**NUMBER:** 23-010-16

**THIS BULLETIN SUPERSEDES SERVICE BULLETIN 23-027-15, DATED JUNE 20, 2015, WHICH SHOULD BE REMOVED FROM YOUR FILES. ALL REVISIONS ARE HIGHLIGHTED WITH **\*\*ASTERISKS\*\*** AND INCLUDE UPDATED OVERVIEW.**

Rear Door Rattle Noise

2014	(VF)	Ram Pro Master (NAFTA)
------	------	---------------------------

**Fig. 1 Left Rear Door Lower Latch**

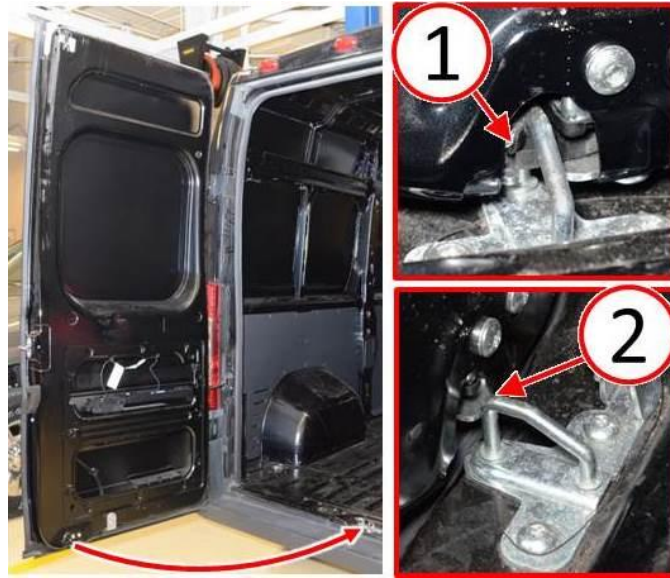
The customer may describe a rear door rattle noise and/or a rear door lower latch not working properly. An example of a properly functioning latch (1) and malfunctioning latch (2) are shown in (Fig. 1).
